Technical product information

Transaction No.: 2026513/5

Engine: rattling noises from front/engine compartment when starting engine

Illustration 2

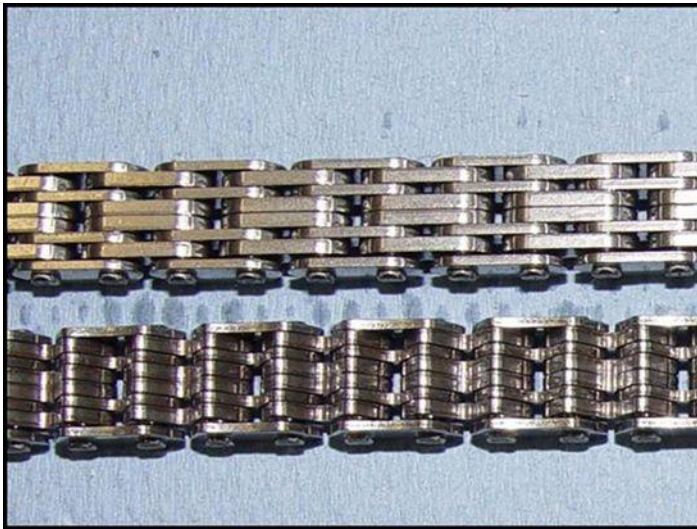
The length of the timing chain has changed because of wear. This leads to:

- Rattling noises when starting the engine.
- Timing chain jumps off.
- Contact between valves and piston.

Illustration 2: old timing chain (inside/outside)

- Fit the repair kit for timing chain (part number: 03F 198 229 A) according to the repair manual.
- If a chain box without guard is fitted:
  - Fit the optimised chain box with guard (part number: 03F 109 210 C) according to the repair manual (illustration 4, green marks).
- Change the engine oil and the oil filter according to the repair manual.

Illustration 3

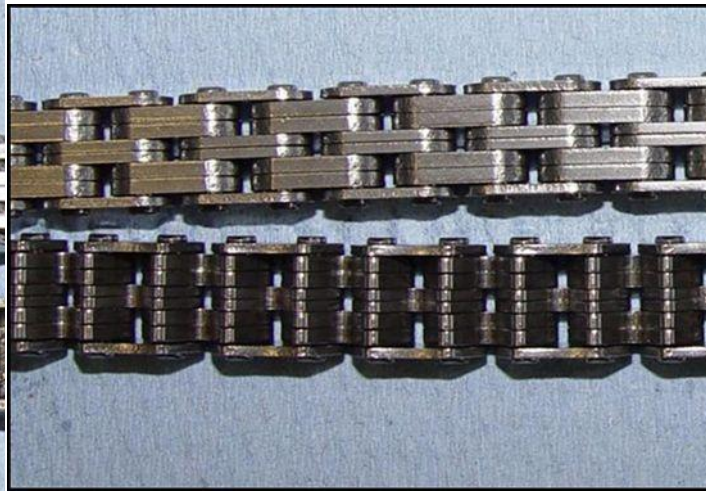
Optimised timing chain from engine number:

- CBZ\* 462774 (Mlada Boleslav).
- CBZ\* 714253 (Salzgitter).

Illustration 3: optimised chain (modified chain clips)
